MIT
KENDALL SQUARE
BUILDING 4

DESIGN UPDATE
SUPPLEMENTAL MATERIALS

MAY 14, 2019

EAST ELEVATION: HAYWARD STREET

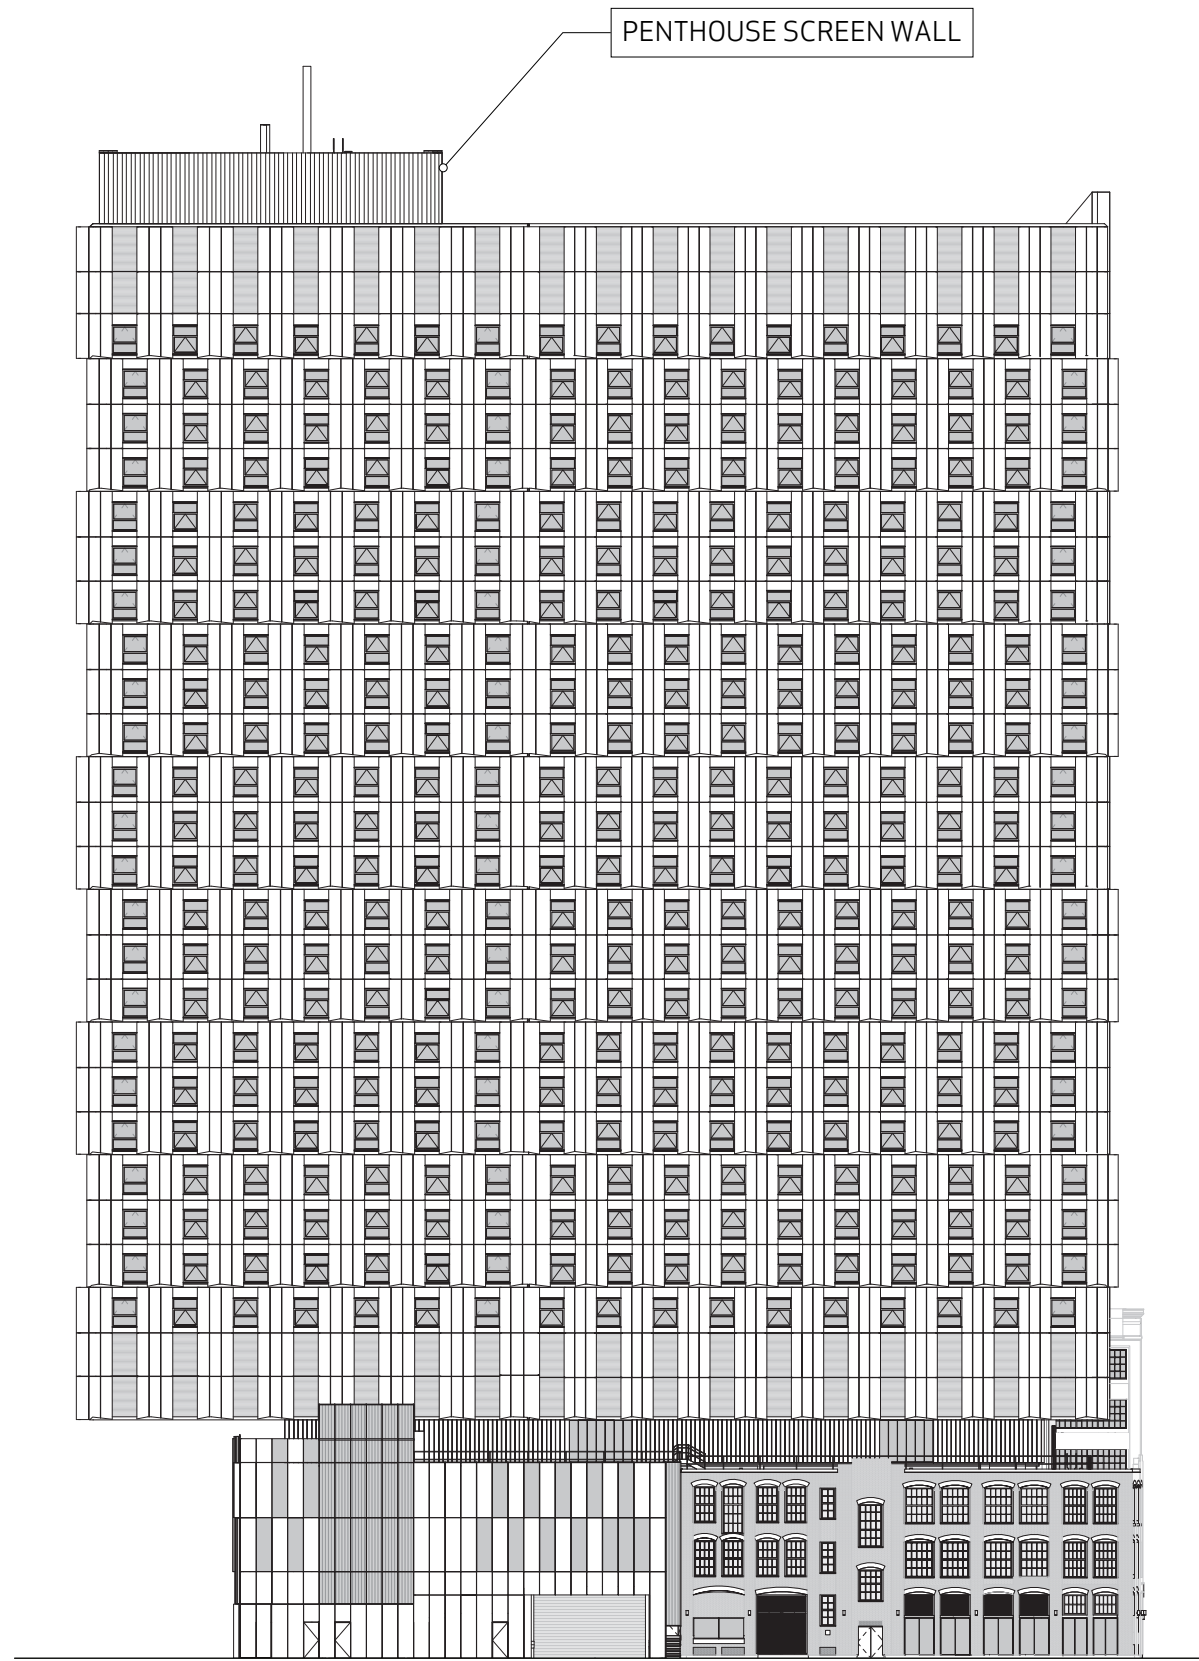
PROPOSED:
REVISE PENTHOUSE SCREEN WALL CORRUGATED, ANODIZED ALUMINUM FROM
CLEAR ANODIZED TO DEEP BRONZE ANODIZED IN COLOR

APPROVED
